RE: October 30, 2004 (Draft for Discussion) Concept for Chemical, Biological, Radiological, and Nuclear (CBRN), Tight Fitting, Powered Air Purifying Respirator (PAPR) Docket-010

3M Comments on October 30, 2004 (Draft for Discussion) Concept for Chemical, Biological, Radiological, and Nuclear (CBRN), Tight Fitting, Powered Air Purifying Respirator (PAPR)

Maximum Inhalation Flow Rate

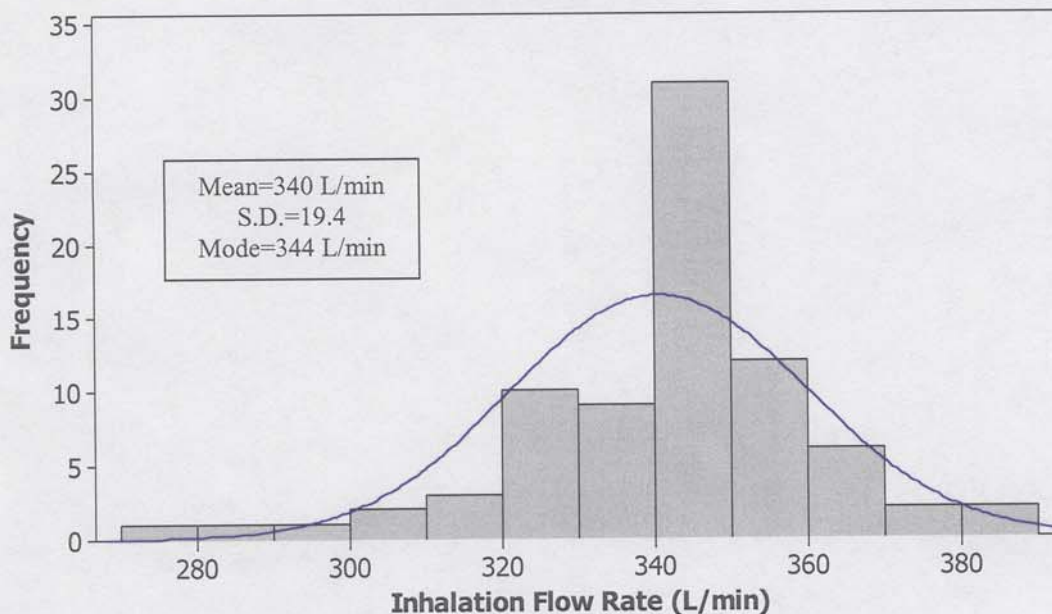
This provision is to be evaluated by a method “to be determined.” This statement replaces a contentious high flow test requirement of 430 liters per minute for five minutes. It is very important that there be another draft concept paper that describes the proposed test before the final version is published. It would not be acceptable to have a test condition inserted without the possibility of comment and would clearly defeat the purpose of the public meetings.

The following histogram is presented in anticipation of that discussion. It represents data collected on the “worst-case” subject in a recently completed respiration physiology study at 3M. The histogram summarizes two minutes of data collected at 80% of the subject’s VO_2 max, comprised of approximately 12,000 data points. The frequency bars represent maximum peak flow rates from 80 breaths during that period, i.e., each occurrence is 0.01 second duration. The salient point is the maximum peak airflow rate that has been the subject of recent debate occurs only once, for 0.01 second. The mean (340 L/min) or mode (344 L/min) is a much more reasonable indicator of an individual’s maximum airflow requirement than is a single maximum peak.

More importantly, since all the peaks in the histogram add up to only 0.8 seconds (out of two minutes) it is clear that an “Emergency Egress Provision” test should not be based on peak airflow rates at all. In our study the 95th percentile minute volume for 15 subjects (nine men and six women) was 110 L/min at 80% VO_2 max. This is close to the 114 L/min minute volume suggested as a reasonable estimate for occupational activities by Caretti.¹ Both values are in general agreement with Kaufman and Hastings’ study of respiratory demands of respirator users at very high work rates (mean minute volume 96.4 L/min).² In all cases the data indicate the 100 L/min flow rate NIOSH already uses for CBRN Full Facepiece APR “panic” testing is appropriate. Since requirements later in this concept paper address PAPR use in a negative pressure mode, it is logical that the 100 L/min total crisis flow rate of the CBRN-APR specification be adopted, divided by the number of filters on the PAPR. This requirement would be technically defensible as well as assuring consistency among regulations.
